**The Los Alamos National Laboratory *Fieldwork Plan for R-22 Well Rehabilitation and Conversion* is Unacceptable and Must be Denied by the New Mexico Environment Department
Report Version February 20, 2009**

By Robert H. Gilkeson, Registered Geologist

Joni Arends, Executive Director

Figure 2. The as-built construction of LANL characterization well R-22.

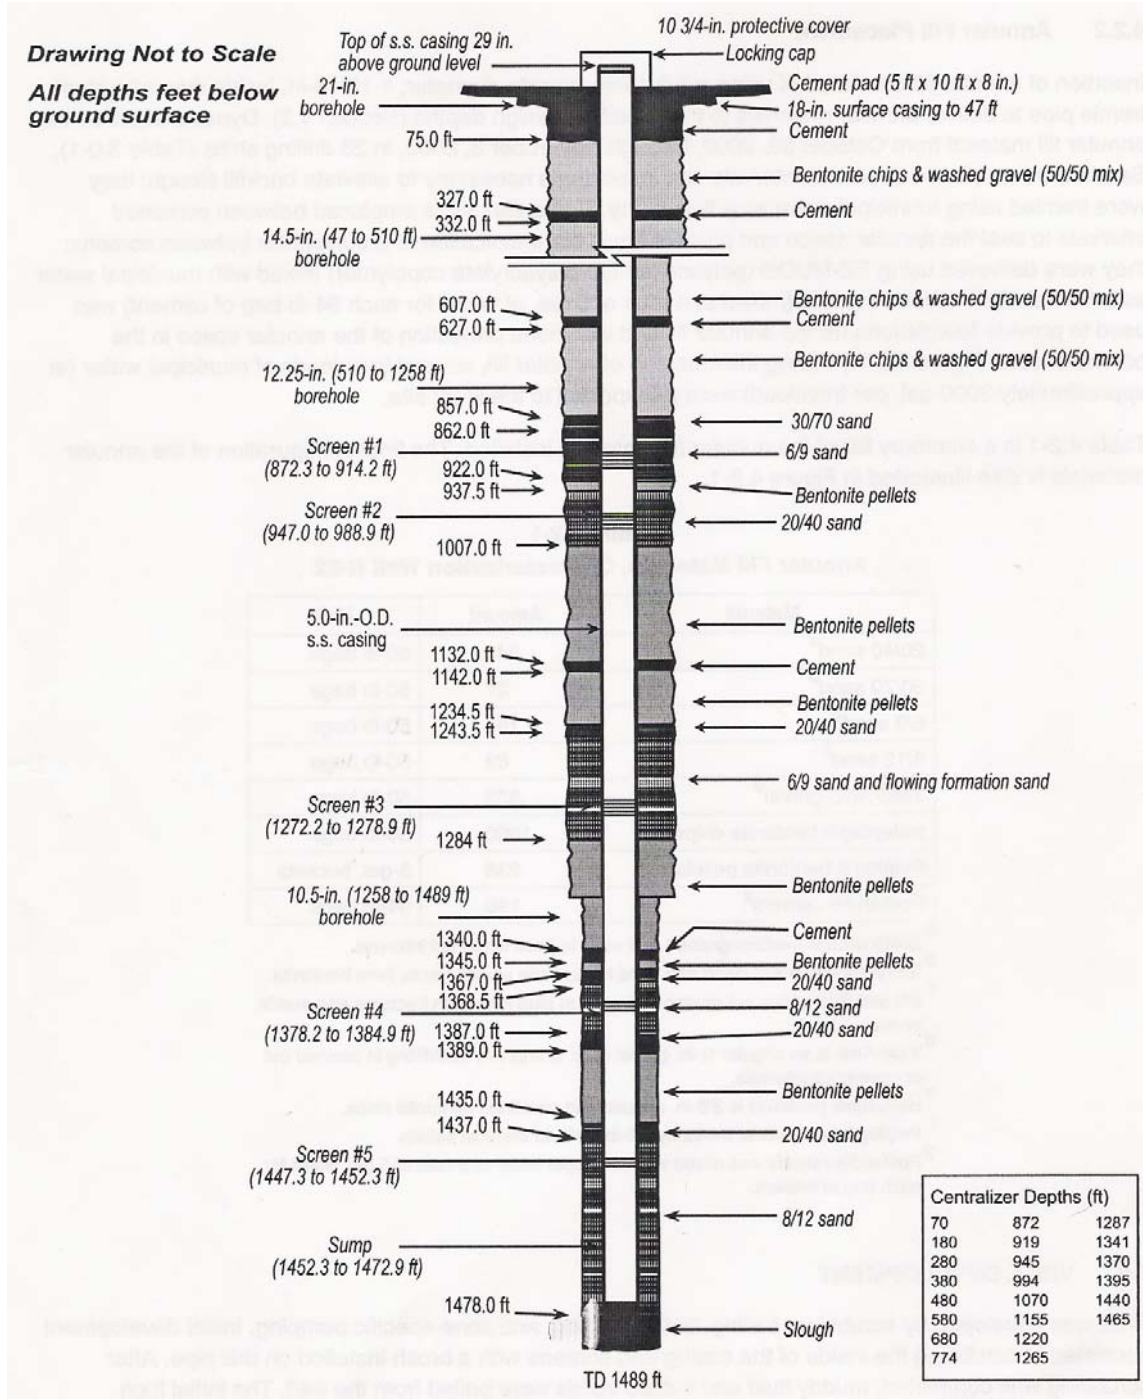
Figure 2 shows the as-built design of well R-22 with five well screens. Screen #1 is installed across the water table and screen #5 is installed at a depth of 560 feet below the water table. When the R-22 borehole was drilled in September of 2000, the top of the regional aquifer was at a depth of 883 feet below ground surface. The R-22 Plan will plug and abandon screens #4 and #5 and seal off screen #1. Jetting procedures will be used to redevelop screens #2 and #3. Then a pumping system will be installed in the well to produce water samples from screens #2 and #3. However, there are many factors that will prevent the rehabilitation of screens #2 and #3 from being successful. Those factors are described in the author's January 28, 2009 report and are summarized below. Well R-22 must be replaced because it does not meet the requirements of RCRA as a monitoring well but it is an important well for measurement of water levels.

- **Screen #2 in well R-22.** The top of the 42-foot long screen is located 64 feet below the water table and in a basalt formation with a very low permeability of 0.04 feet per day (0.04 ft/day). The R-22 Plan makes the mistake to assume that screen #2 samples groundwater at the water table but the seven foot lower water level measured in screen #2 compared to screen #1 is evidence that there is little hydraulic communication between screen #2 and the water table. The available information shows that screen #2 is installed in a section of the basalt that only produces small quantities of groundwater. It is a requirement of RCRA 264 Subpart F and the NMED Consent Order to install monitoring wells in productive aquifers that are along the expected pathways for contaminated groundwater to travel from waste disposal sites. Screen #2 is installed in a confining bed that is not a pathway for groundwater contamination from MDA G.

- The top of the 7-foot long well screen is located 390 feet below the water table and below thick layers of highly permeable aquifer strata that are not monitored by either screen #2 or #3.

- For comparison, the permeability measured at screen #3 was a low value of 0.21 ft/day. The well R-22 lithologic log describes the unconsolidated sediments surrounding screen #3 as "very fine silty sand to pebble gravel" - a description of poorly sorted sediments that have low permeability and are not productive aquifers.

- The R-22 Plan does not describe the mistake during the construction of well R-22 that invaded the filter pack sediments surrounding screen #3 with the bentonite clay grout materials that were used to seal the well annulus. The bentonite clay has well known strong properties to prevent the detection and accurate measurement of many contaminants from MDA G.

Figure 3. Schematic of the pipe-based wire-wrap stainless steel well screen installed in many of the LANL characterization well R-22.

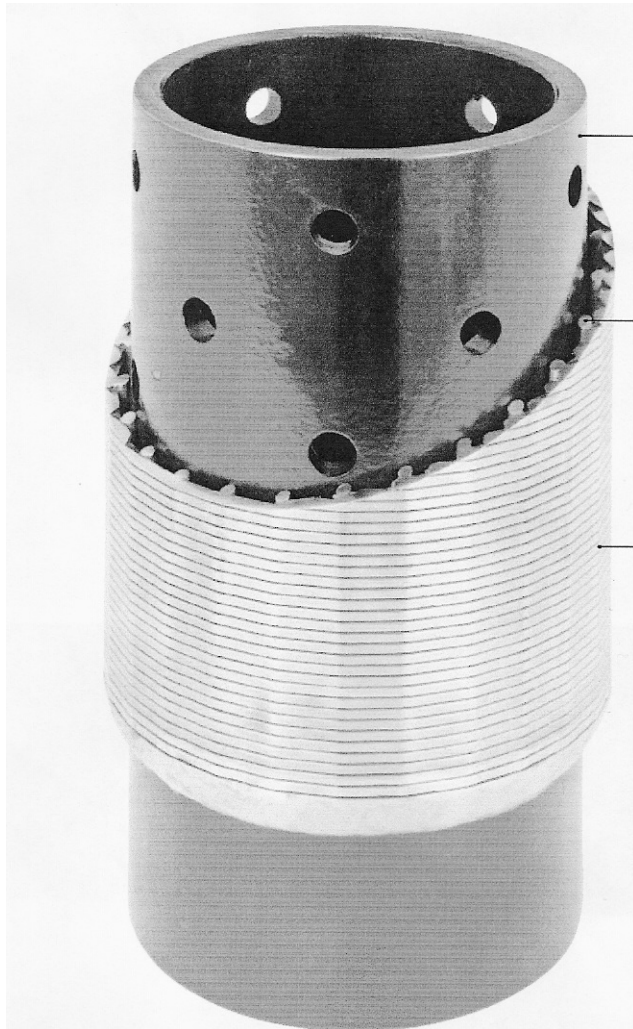
- The R-22 Plan does not recognize the LANL reports that show the well development performed in November of 2000 was not successful in removing the organic drilling additives or the bentonite clay grout from screen #3. The pipe-based design of the well screen is one factor that prevented the well development from being successful. The restrictive design of the pipe-based screen is displayed and described in Figure 3.

- The R-22 Plan does not recognize that the restrictive design of the pipe-based well screen will also prevent the redevelopment activities in the R-22 Plan from being successful in cleaning the new reactive mineralogy and the grout contamination from screen #3.

- The pipe-based screens in LANL characterization well R-22 are constructed with 84 holes drilled through the base pipe per linear foot of screen. The drill holes have a diameter of 0.375 inches.
- The surface area of the holes drilled through the base pipe is only 5% of the surface area of the well screen.
- The restrictive design of the pipe-based screens prevented the original well development activities from removing the organic drilling additives from the five screened intervals in well R-22.
- The restrictive design of the pipe-based screens will prevent the rehabilitation activities in the R-22 PLAN from removing the new mineralogy created by the organic drilling additives and the bentonite clay grout contamination from screen #3 in well R-22.
